A.G. Dresses Ltd, Pinaki Garments Ltd, Pinaki Seha Industries Ltd, Seha International Bangladesh Ltd.

Plot-9 Block-C Tongi Industrial Area, Haimardighi, Tongi Gazipur
(23.899N, 90.405E)

1st March 2014

Observations

Flat Slab Design

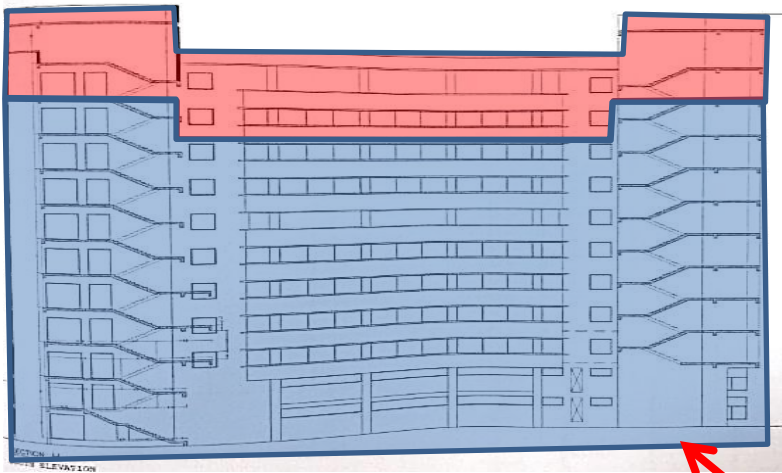
Cursory Calculations indicate high shear stress at column heads.

Shear reinforcement not indicated on the drawings presented for inspection.

Building Engineer to check punching shear for the slab at all levels

Heavy Water Tanks on Roof Slab

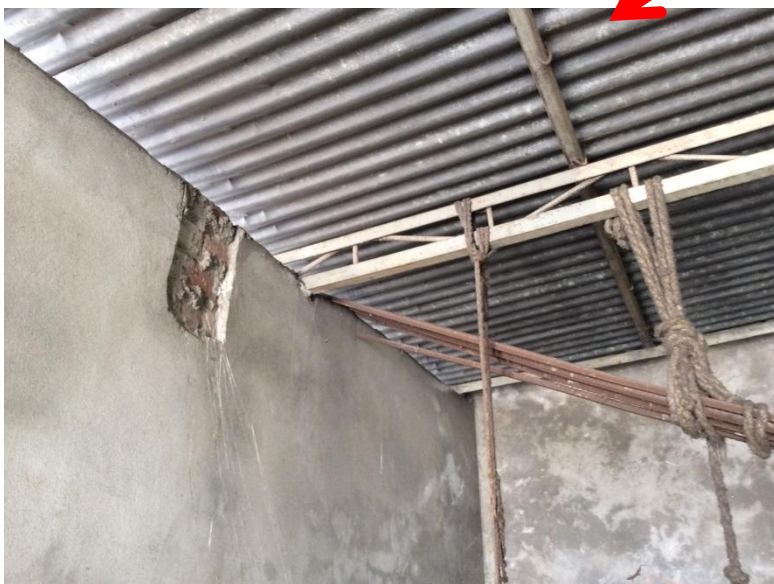
Heavy Water tanks on Roof Slab

3000 litre Fire water tanks

Building Engineer to check that beam and slab have been designed to accommodate loads.
